ACCESSION NBR: 8201060307 DOC. DATE: 81/12/30 NOTARIZED: NO DOCKET #  
 FACIL: 50-244 Robert Emmet Ginna Nuclear Plant, Unit 1, Rochester G 05000244  
 AUTH. NAME AUTHOR AFFILIATION  
 MAIER, J.E. Rochester Gas & Electric Corp.  
 RECIPIENT NAME RECIPIENT AFFILIATION  
 CRUTCHFIELD, D. Operating Reactors Branch 5

SUBJECT: Forwards comments on NRC-810727 draft evaluation of SEP  
 Topic VI-4, "Containment Isolation Sys." Two oversize  
 drawings encl. Aperture cards are available in IPDR.

Subject: SEP Topic VI-4, Containment Isolation System  
R.E. Ginna Nuclear Power Plant  
Docket No. 50-244

PT 23.34 DEPRESSURIZATION AT POWER  
PENETRATION NO. 132

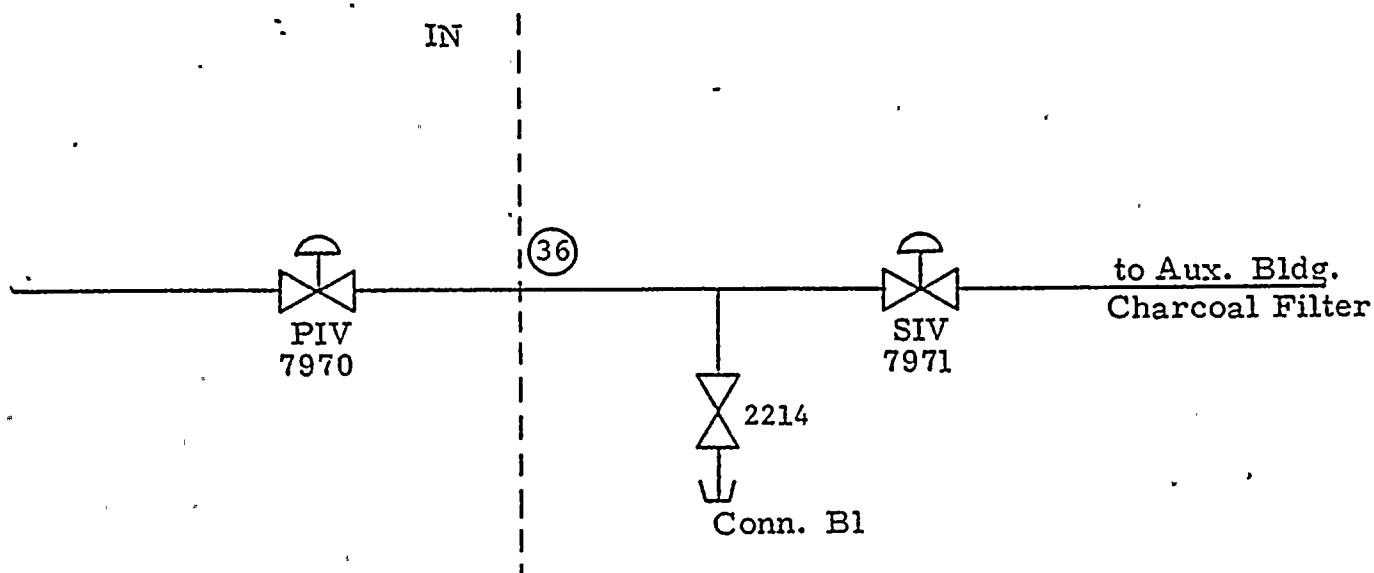
Penetration 132 (36) (33013-533), depressurization at power, was found acceptable with one automatic isolation valve inside containment (AOV 7970) and one automatic valve outside containment (AOV 7971).

## PENETRATIONS 201 TOP AND 209 BOTTOM

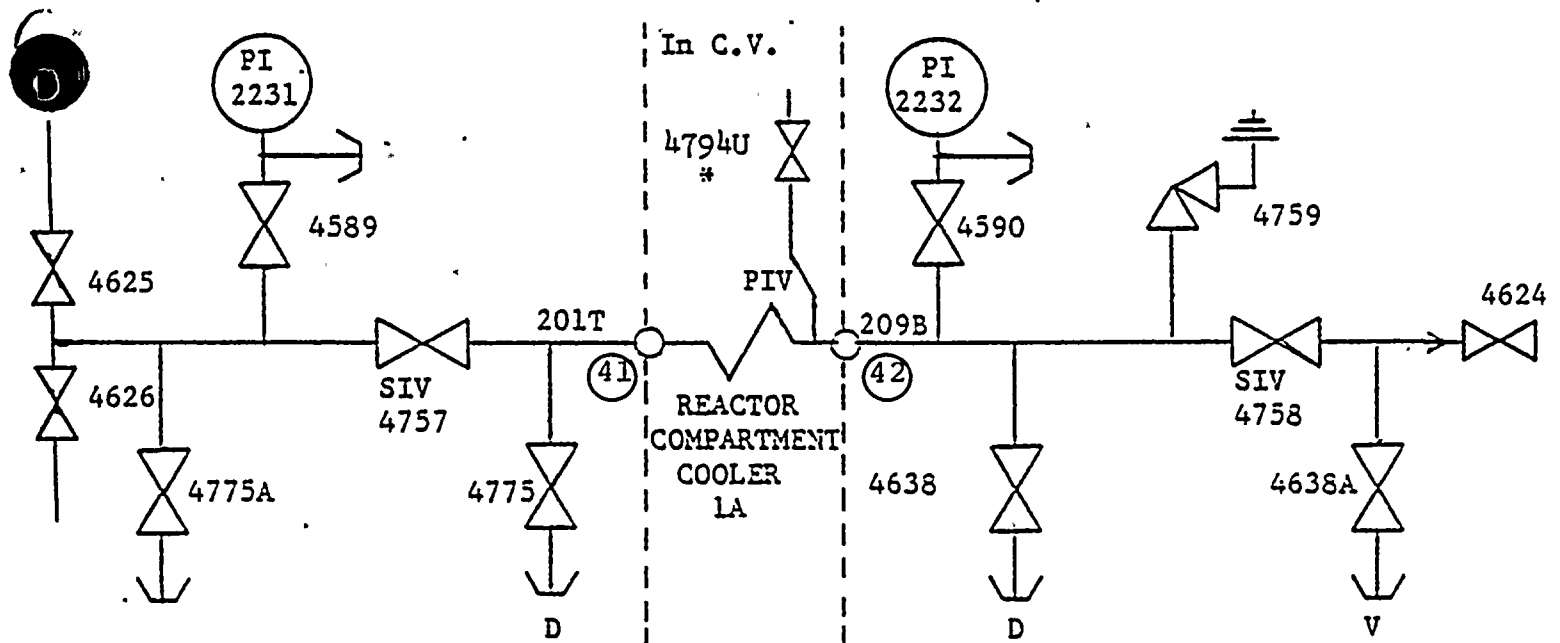
Penetrations 201 and 209 (41 and 42) (33013-529), service water to reactor compartment cooling units A and B, are provided with manual isolation valves outside containment on both the inlet and discharge piping of the coolers. The coolers and piping inside containment form a closed system and are protected throughout their length from missiles. Thus, the only deviation from the current criteria of GDC 57, the applicable criterion, is

that the isolation valve is not remotely operable. The service water system operates at a pressure higher than the peak containment pressure so that any leakage from the cooling system will be into the containment, not from the containment. A radiation monitor is provided on the service water discharge from the containment to alert the operator to abnormalities. The isolation valves are located in the intermediate building only a short distance from the control room. Entrance to this area does not require protective clothing or entry through a controlled area. The isolation provisions for these lines are acceptable for continued operation. The need for remote manual operators on the valves will be further evaluated during the integrated assessment.
